ADDENDUM

PROJECT: South Dakota State University
New Headhouse & Greenhouse
Headhouse Finish Package
Brookings, South Dakota

AD-1

DATE ISSUED: March 08, 2013

Drawing #
A-101.1

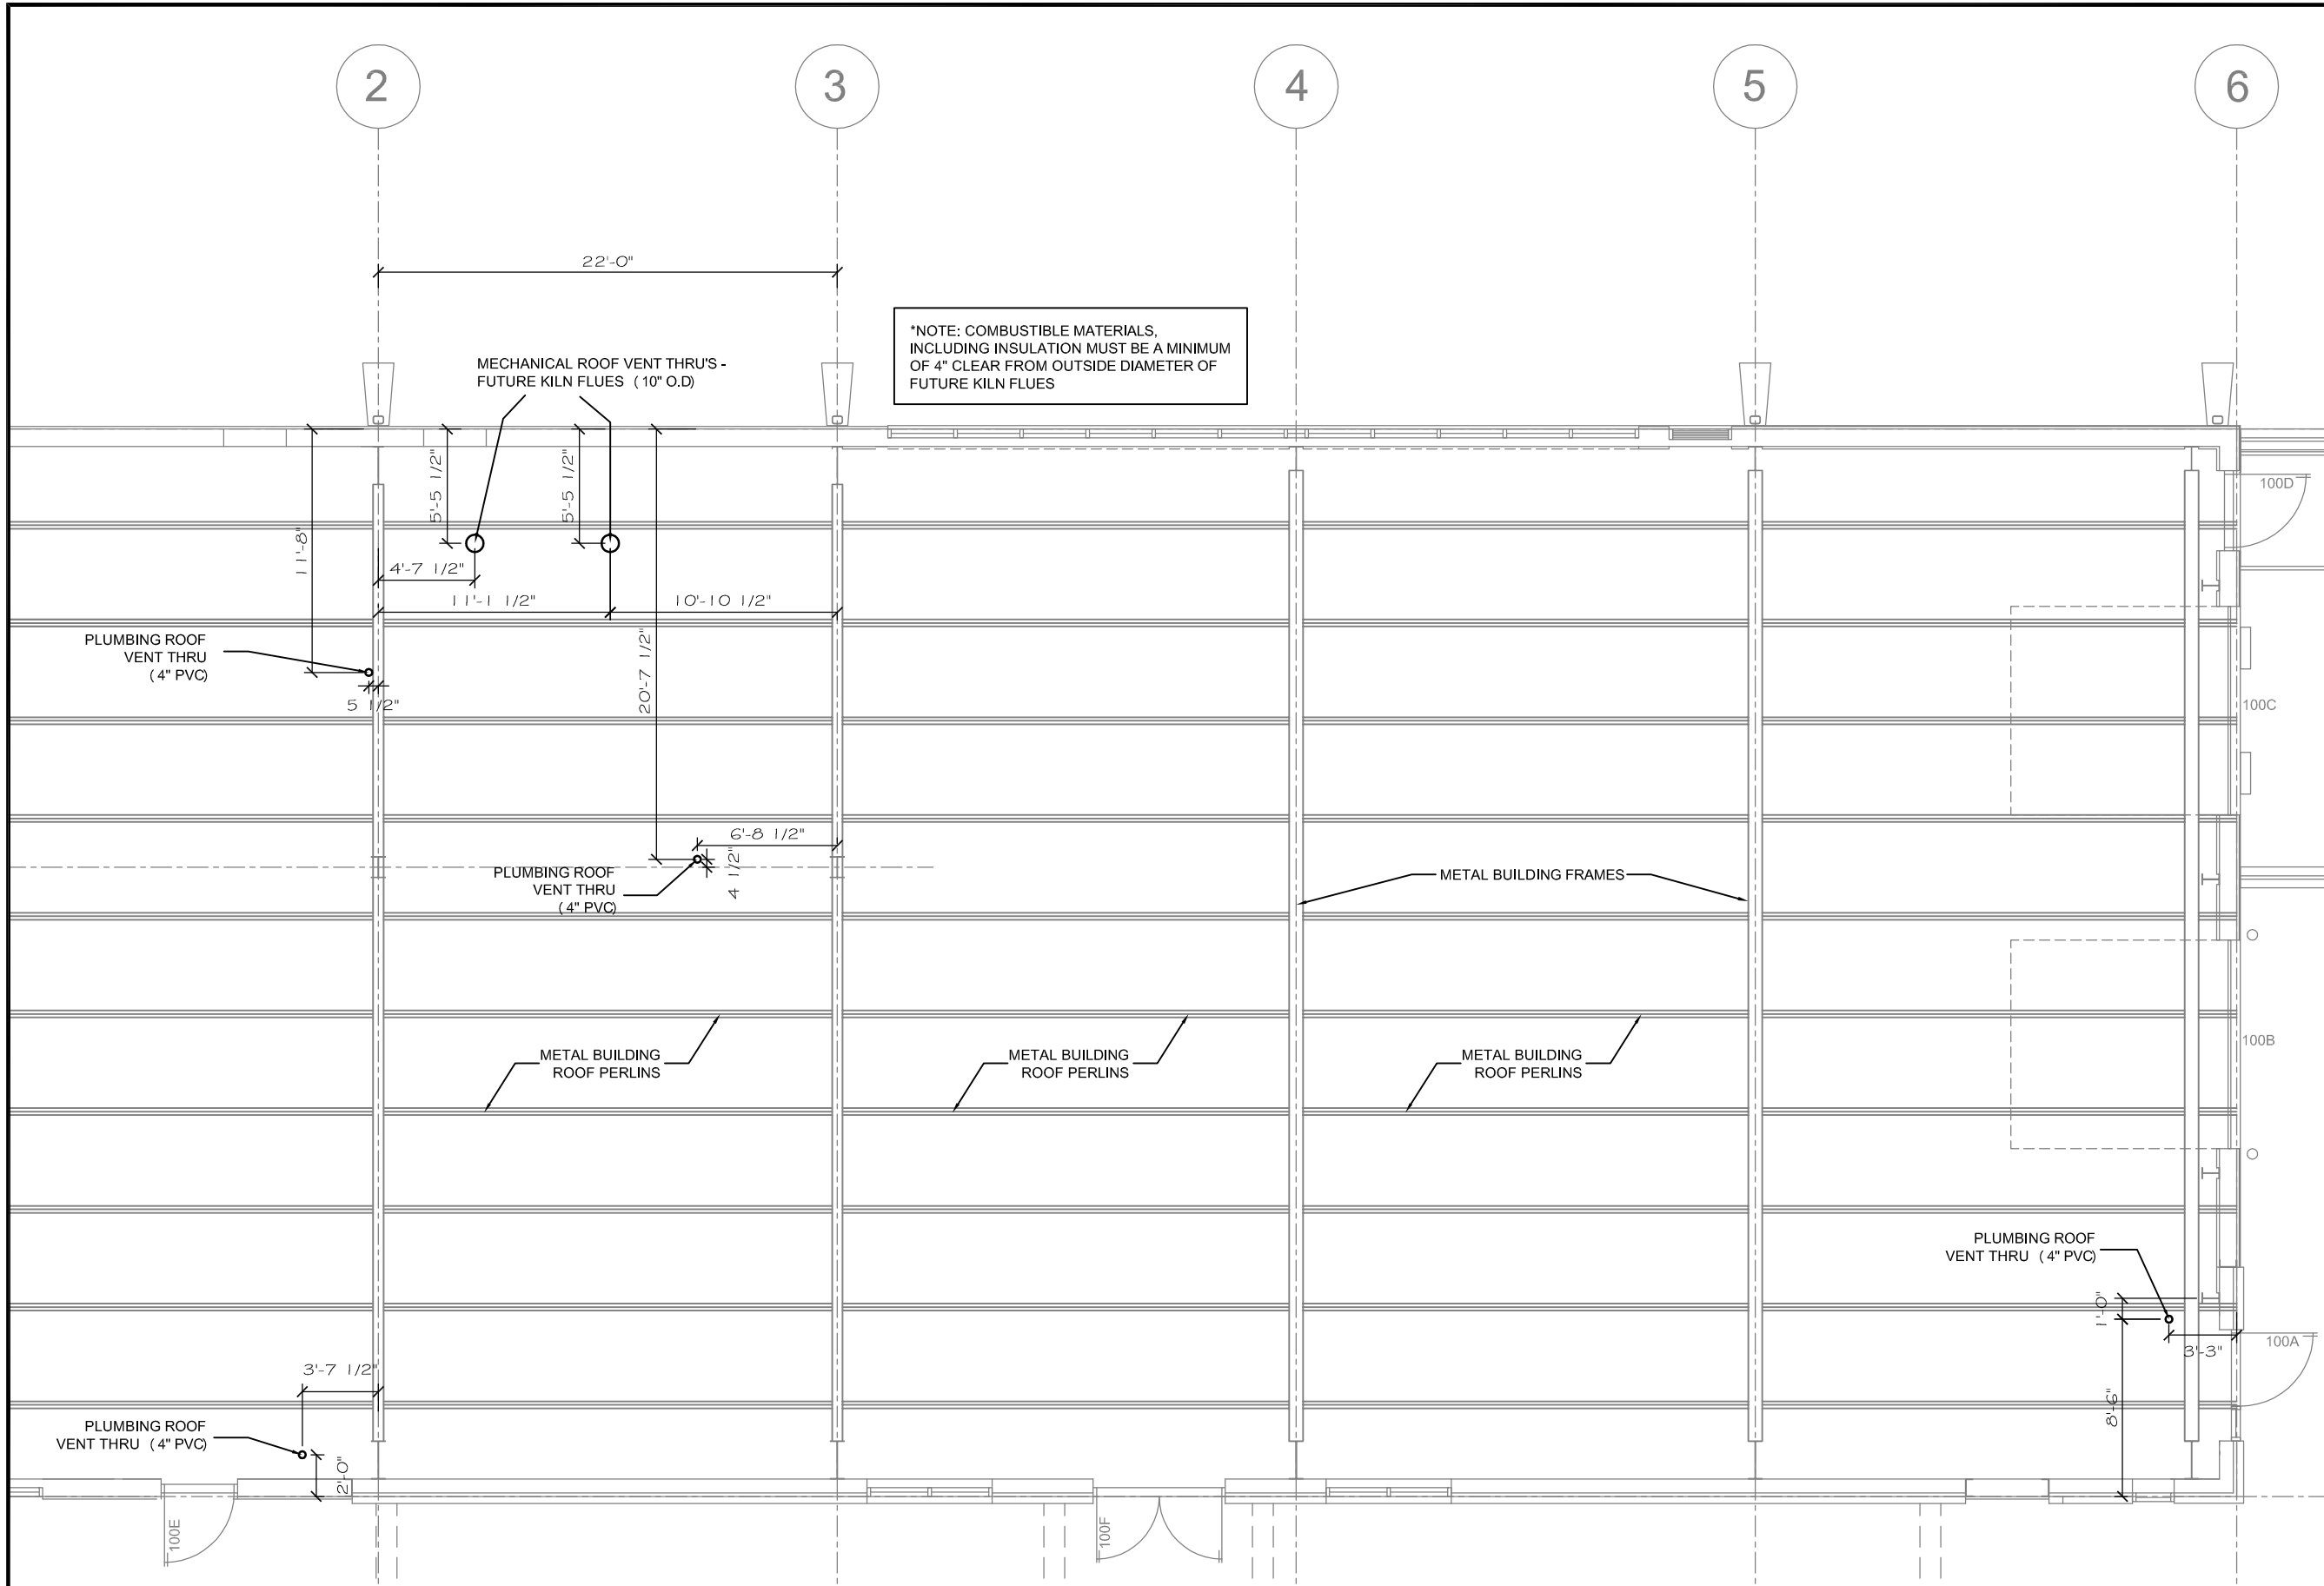
In reference to drawing sheet A-101-reference the attached drawing A-101.1 for revisions to walls and sink locations. Reduce West wall of Room Photo 110 to 2'-6". Remove walls South and West of Column on Grid Lines A and 3. Rotate sink to be on south wall as shown. See Plumbing revisions in this addenda for revised piping plans.

From Sheet:	N/A	for CA use:
Drawing #	A-105.1

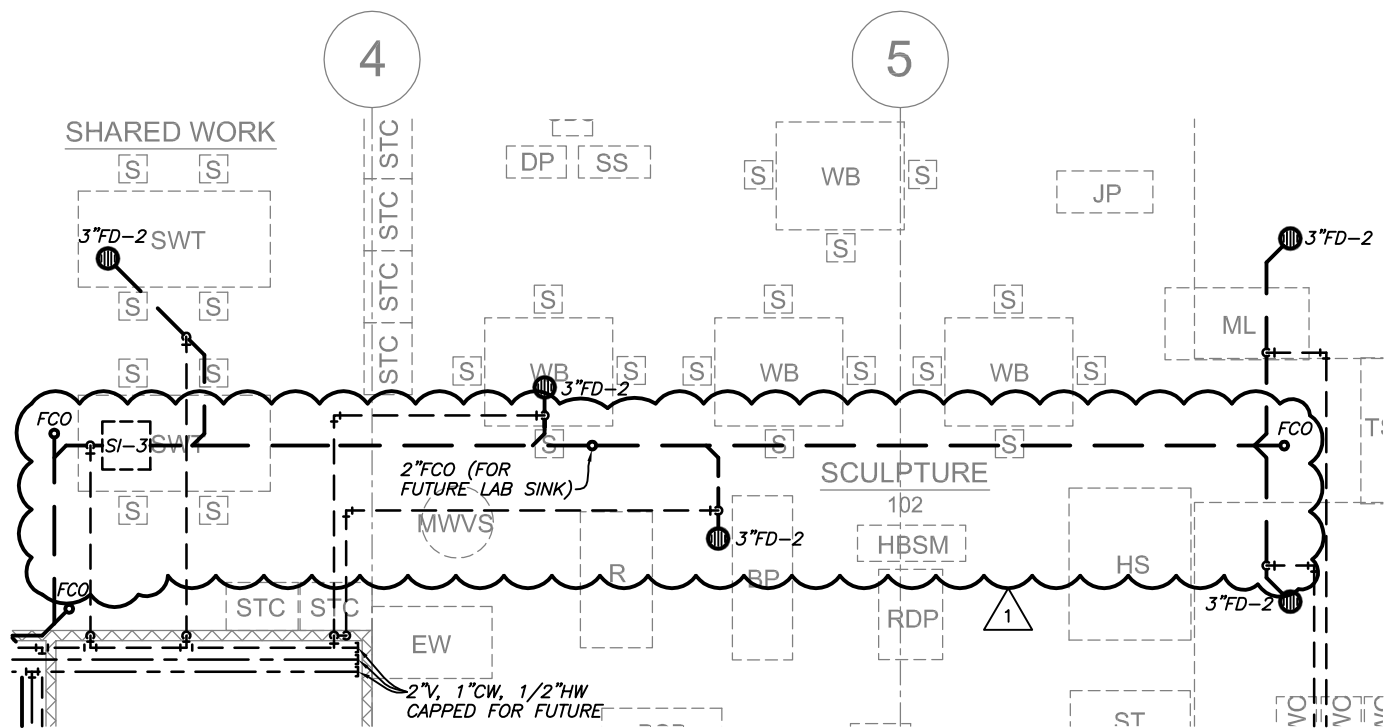
In reference to drawing sheet A-105-reference attached drawing A-105.1 which notes the roof penetrations for plumbing and mechanical vent thru's. Field verify existing metal building roof structure. Coordinate with plumbing and mechanical plans for necessary connections.

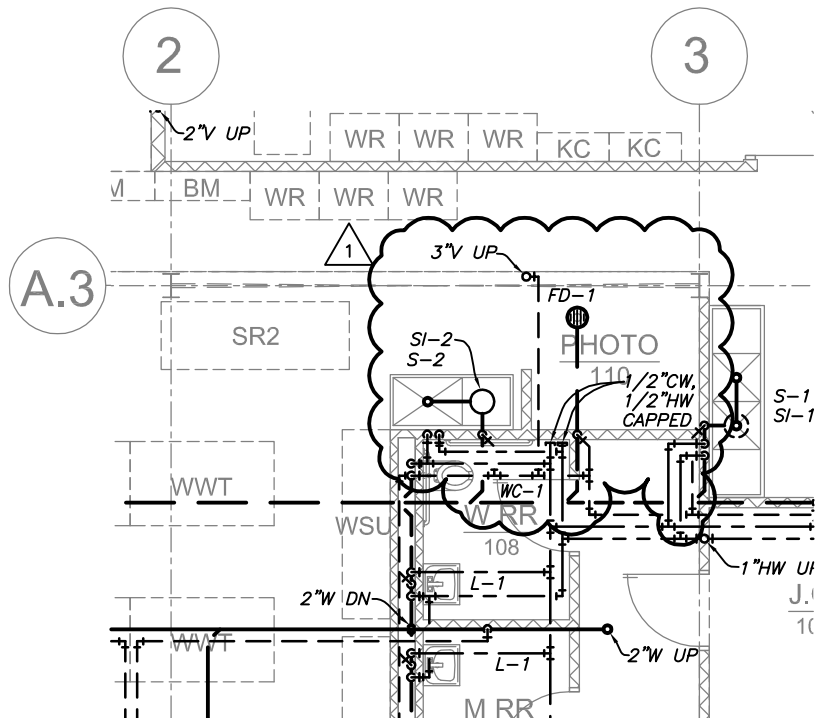
In reference to drawing sheet P-101 and P-501, reference attached sketches P-101.1, P-101.2, P-501.1 and P-501.2 for revisions to plumbing plans.

From Sheet:	E-101	for CA use:
Drawing #	E-101.1

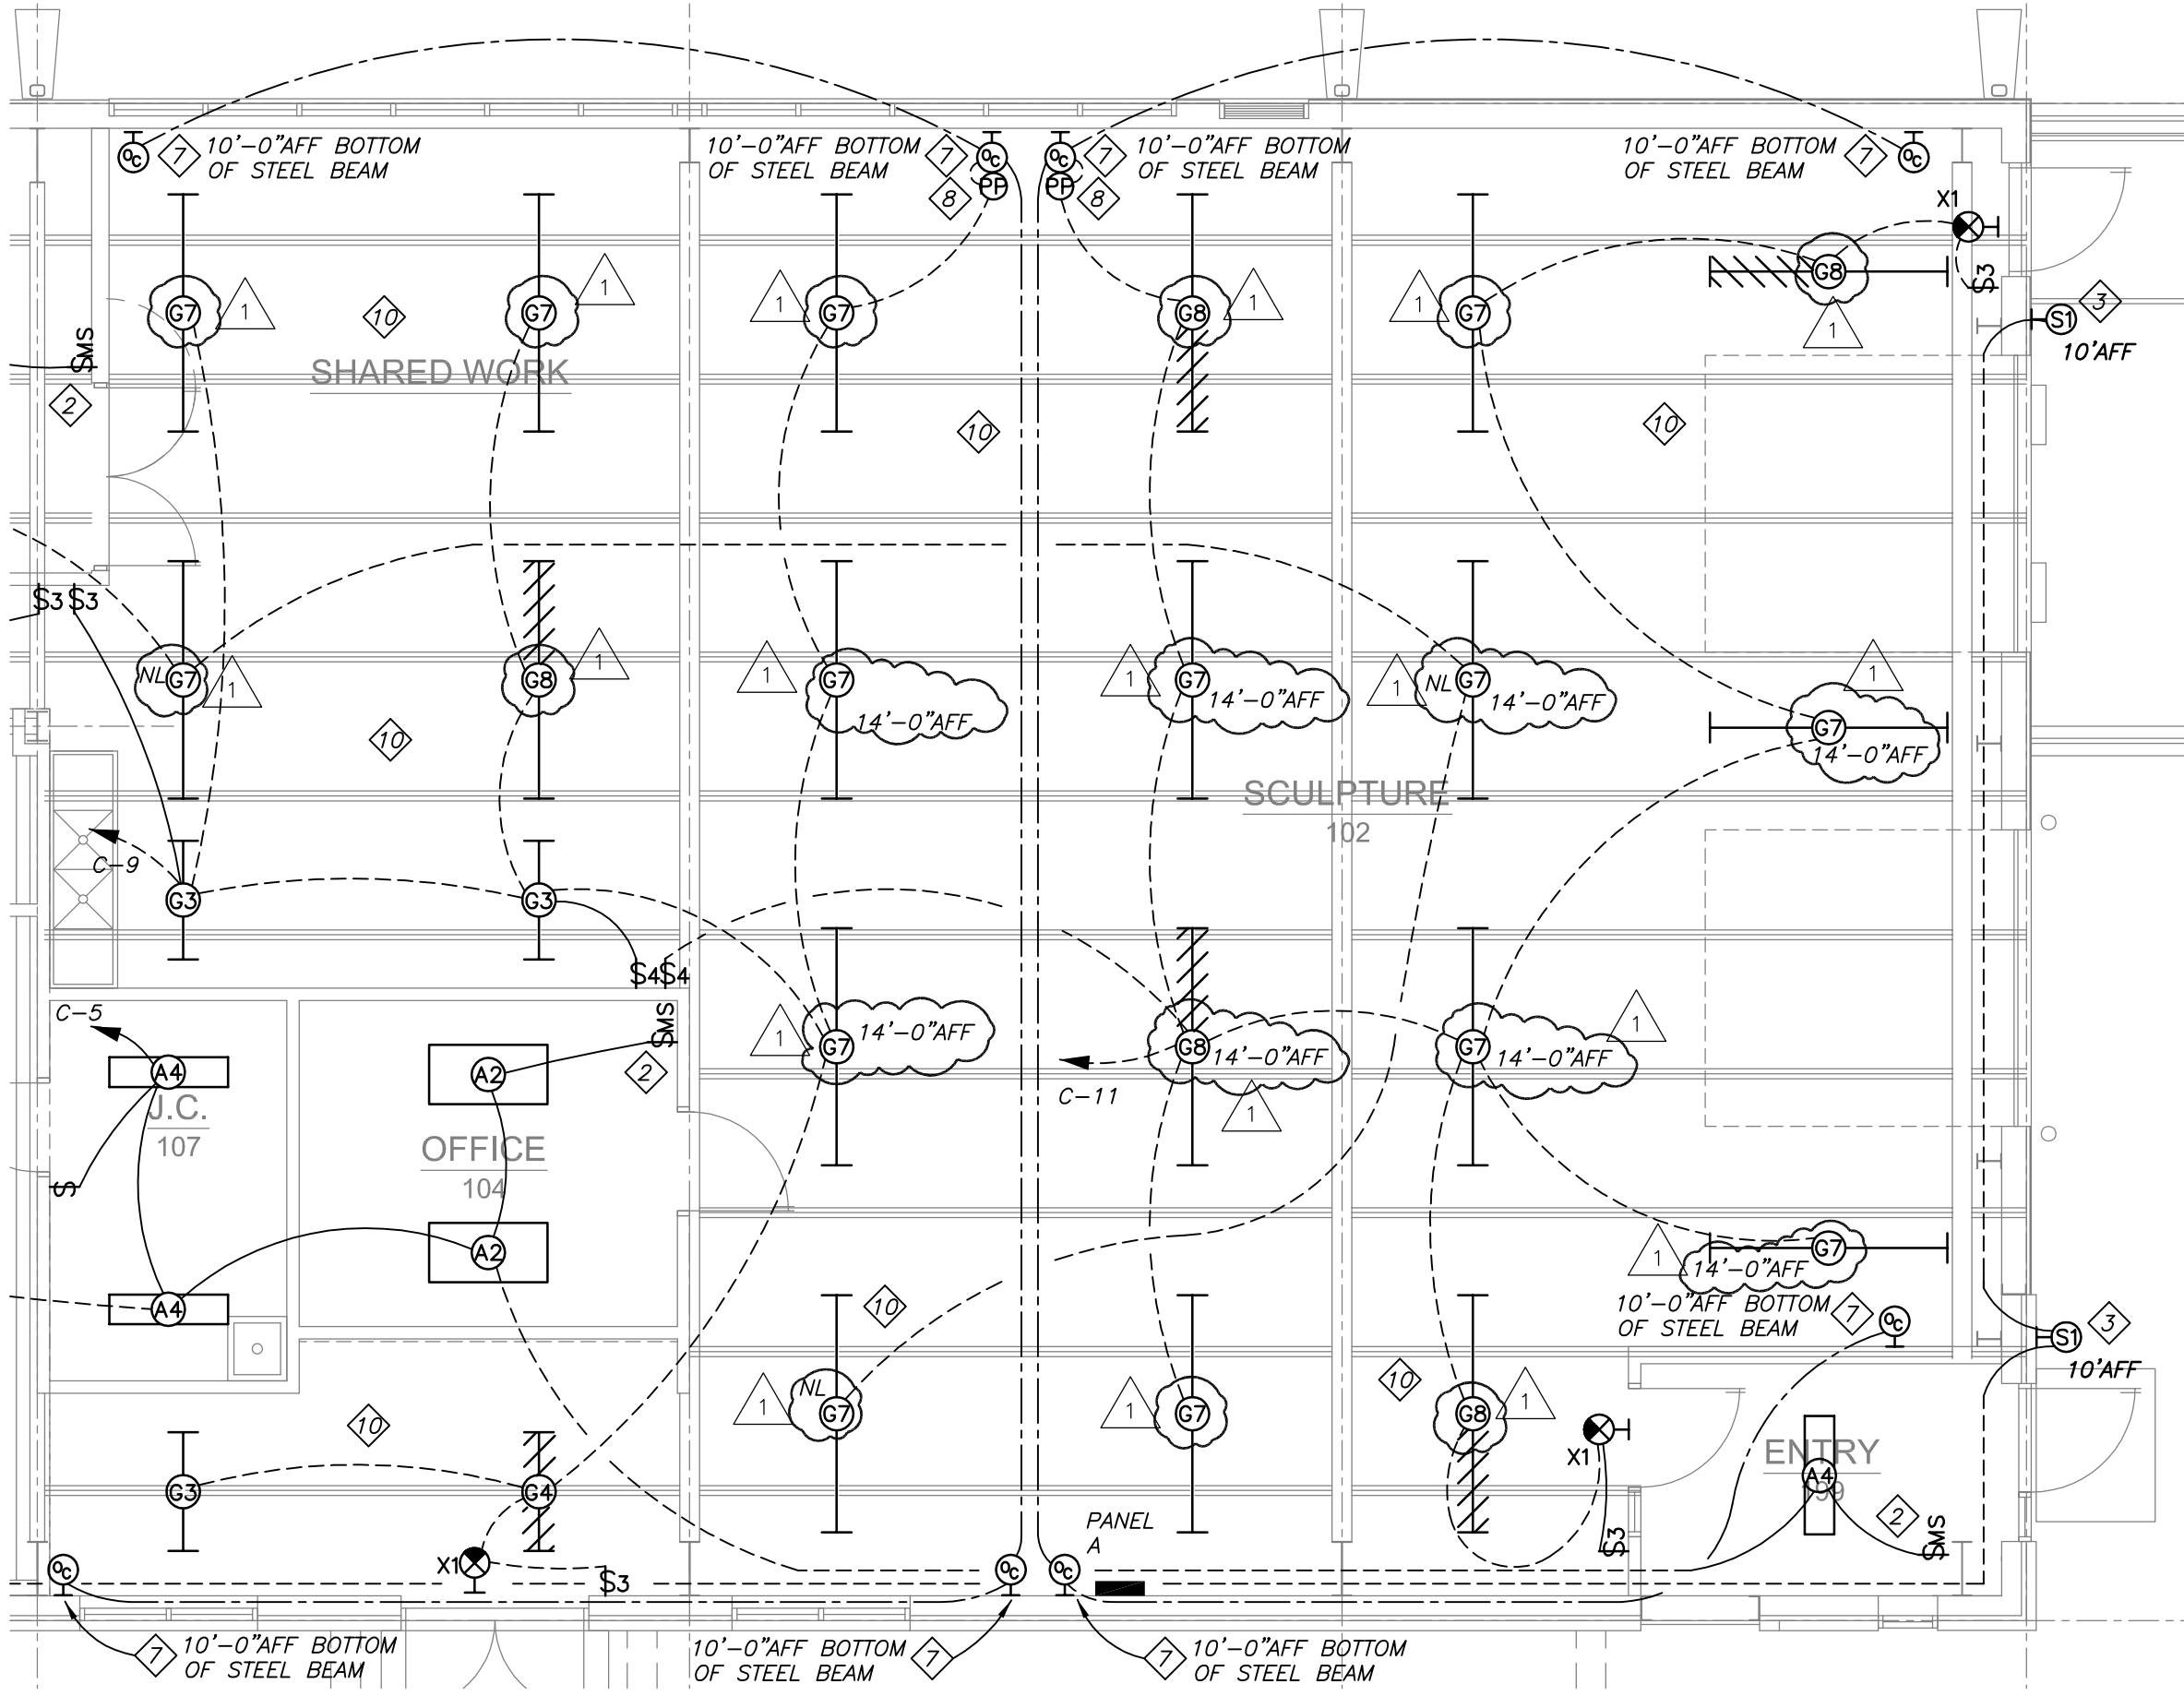
In reference to drawing sheet E-101, see attached Supplemental Drawing E-101.1 for fixture changes.
